Azmeri Composite Knit Ltd (Extension Buildings)

25th October 2021

Buildings Information

Material property in provided Design Report

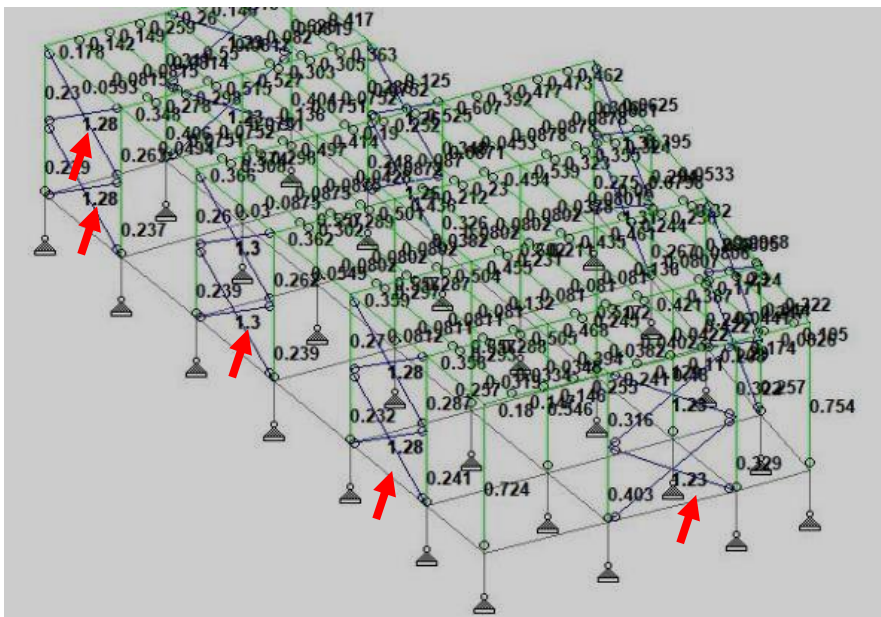
Vertical pipe bracing - overstressed

In provided design report, steel plate strength, concrete compressive strength and allowable bearing capacity of soil have been considered 50 ksi, 3379 psi and 2.6 ksf respectively. No credible test report has been found regarding that values. On the other hand, vertical pipe bracing are overstressed in provided FEM. Factory is required to revise the full set of Design Report in compliance with section 1.9.1.1 and section 1.9.1.2 of BNBC and submit to RSC for further review.
